6.1 **2 & 6 JACKA BOULEVARD, ST. KILDA**
LOCATION/ADDRESS: **2 & 6 JACKA BOULEVARD, ST. KILDA**
EXECUTIVE MEMBER: **KYLIE BENNETTS, GENERAL MANAGER, CITY GROWTH AND DEVELOPMENT**
PREPARED BY: **PHILLIP BEARD, PRINCIPAL PLANNER**

1.1 To determine an application for the partial demolition of the existing building, construction of buildings and works at second floor level; ground and first floor additions to the south-east side of the building; new café with outdoor seating at ground level, increase of 'red line area' for the sale and consumption of liquor and dispensation of car parking requirements.

WARD:	Lake
TRIGGER FOR DETERMINATION BY COMMITTEE:	More than 16 objections
APPLICATION NO:	PDPL/01207/2021
APPLICANT:	Hansen Partnership
EXISTING USE:	Restricted Place of Assembly (Royal Melbourne Yacht Squadron)
ABUTTING USES:	Informal Outdoor Recreation
ZONING:	Public Parks and Recreation Zone
OVERLAYS:	Heritage Overlay (HO225, HO348)
STATUTORY TIME REMAINING FOR DECISION AS AT DAY OF COUNCIL	Expired

Figure 1 : Proposed Ground level

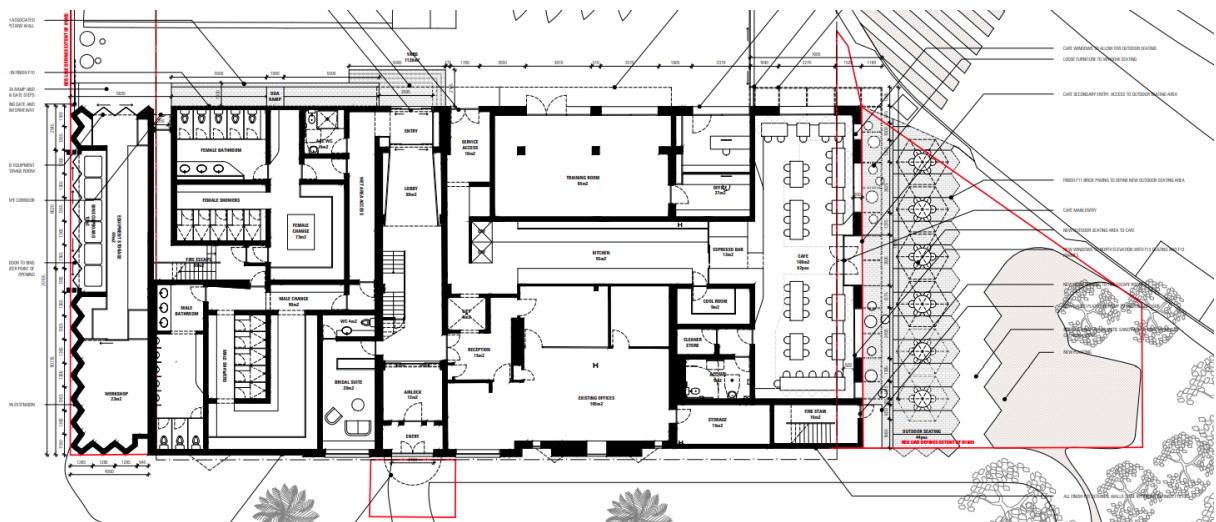
- 5.8 The proposed café would be located to the north-west of the building at ground level. The café would have an internal floor area of 100m² and an internal capacity of 62 patrons. An external seating area is also proposed with capacity for a further 44 patrons. The external area would replace the existing gravel car parking spaces to the north west of the building. Beyond the proposed brick paving to the external seating area, no external buildings and works are proposed to this space with all proposed tables and chairs being movable.

Figure 3 Proposed second/roof level

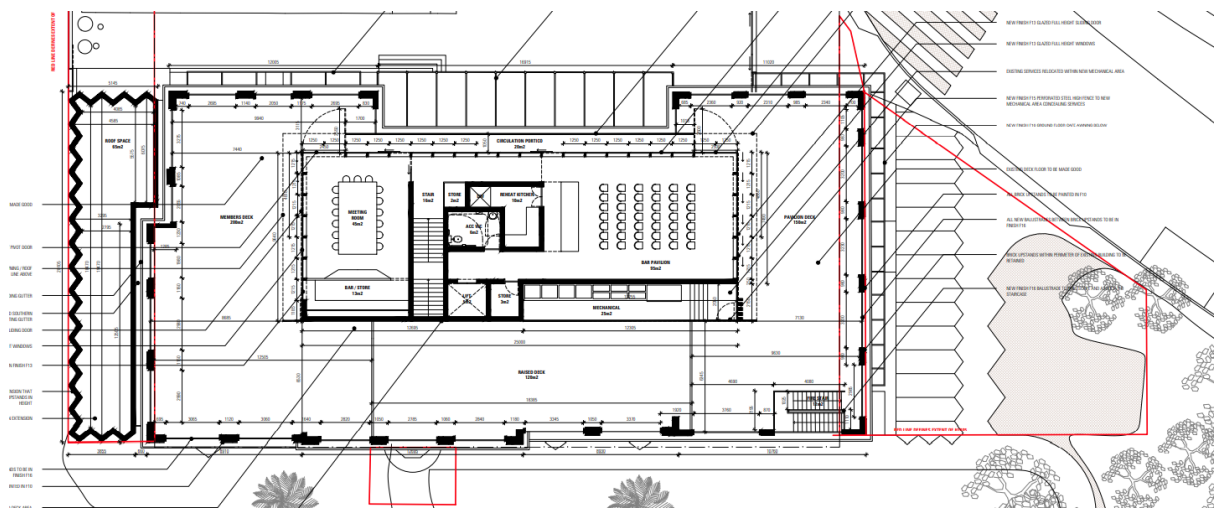
- a) The roof deck structure reduced in size through an increased setback from the south east edge of the existing building by at least 4m with consequential reduction to the floor area to the meeting room/bar/store.

- b) An increased setback of at least 3.4 metres from the north-west edge of the building with consequential reduction of the pavilion space and any consequent relocations of roof plant.

The building already has a roof terrace that has for several years been used for club activities and functions. The proposal would result in the extent of the rooftop being increased in size, but it would continue not to be publicly accessible, and it would not involve any change in the club's operating hours or require any new patron/club member number restrictions. That is, it would operate largely as it currently does but with some greater focus on some internalised uses, noting that the meeting room, bar and portion of the pavilion would need to be significantly modified to comply with recommended conditions 1 (a) and 1 (b). In any case, the new roof structure would be largely enclosed.
